Intel Atom[®] Processor E3800

Specification Update

May 2018

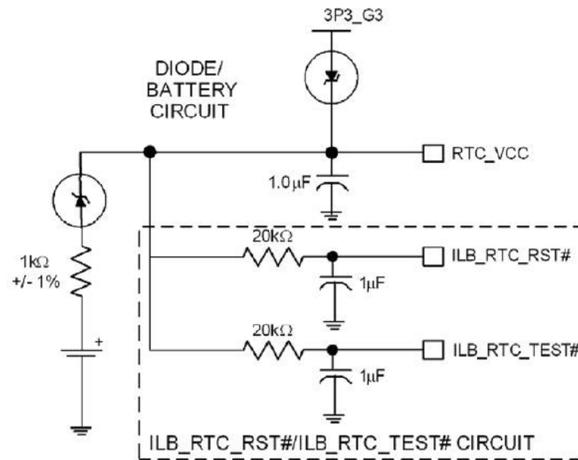
2. ECC Error Reporting Description

The Intel Atom® processor E3800 Product Family only supports memory ECC error reporting as an error count. No other form of error reporting is supported, including access to the error syndrome.
